URGENT FIELD SAFETY NOTICE

Tibial Components / Modular Joint Component Units of
Endo-Model – M Modular Knee Prosthesis System

Tibial Components of
Endo-Model SL Rotational and Hinge Knee Prosthesis System

Endo-Model SL

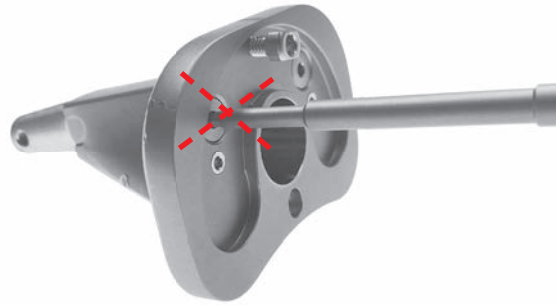
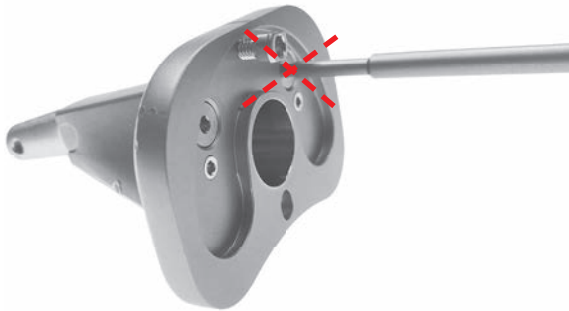
If a Tilastan proximal spacer is to be used and either one or both blind screws of the modular tibial component cannot be loosened, then the following modified surgical technique is to be performed.

= screw removal impossible?

It has to be observed that a homogenous cement mantle between the Tilastan proximal spacer (full & half) and modular tibial component is ensured. The cement mantle should be 1-2 mm thick.

Endo-Model – M

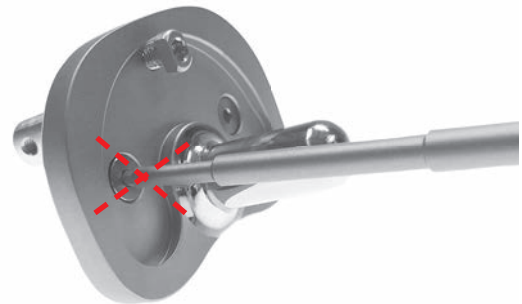
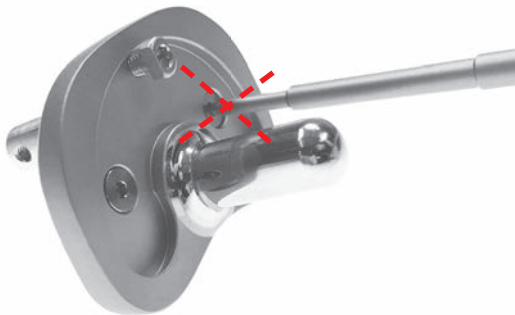
If a Tilastan proximal spacer is to be used and either one or both blind screws of the modular tibial component cannot be loosened, then the following modified surgical technique is to be performed.

= screw removal impossible?

It has to be observed that a homogenous cement mantle between the Tilastan proximal spacer (full & half) and modular tibial component is ensured. The cement mantle should be 1-2 mm thick.
